Author Comments (ACs)

The manuscript title has been updated to "Synthesizing Global Carbon-Nitrogen Coupling Effects – the MAGICC Coupled Carbon-Nitrogen Cycle Model v1.0" This new title more accurately reflects the content and scope of the manuscript and is in line with the title used for other modules of MAGICC (e.g., Synthesizing long-term sea level rise projections – the MAGICC sea level model v2.0, https://doi.org/10.5194/gmd-10-2495-2017).

RC3: 'Comment on egusphere-2024-1941', Junichi Tsutsui, 24 Oct 2024

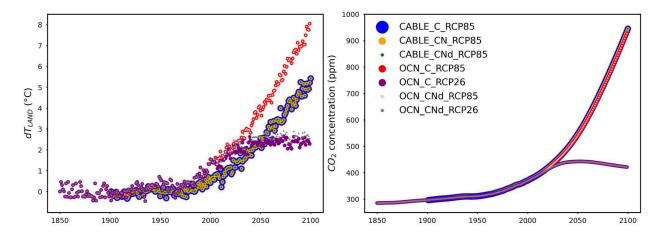
L897–899. For the land organic nitrogen pool size, the differences between the models are too large to identify the trend from the figure.

GT: Thanks for the comments. I have now removed the "land organic nitrogen pool size" as the trend is not that obvious. The revised is as follows:
